Informal document **GRSP-60-01**  
(60th GRSP, 13-16 December 2016,  
agenda item 19)

# Regulation No. 129

Proposal for Supplement 2 to the 02 series of amendments - ECE/TRANS/WP29/GRSP/  
2016/xx: 20 September 2016

# Uniform provisions concerning the approval of Enhanced Child Restraint Systems used on board of motor vehicles (ECRS)

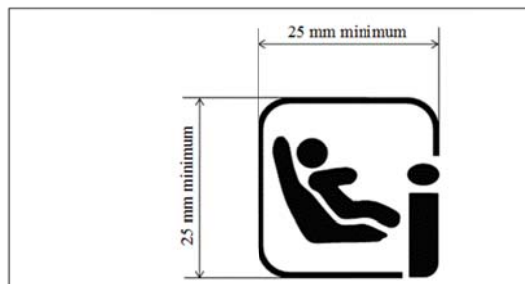
The marking shall be located on the part of the ECRS which includes the ISOFIX **attachments**.

Deleted: **connectors**
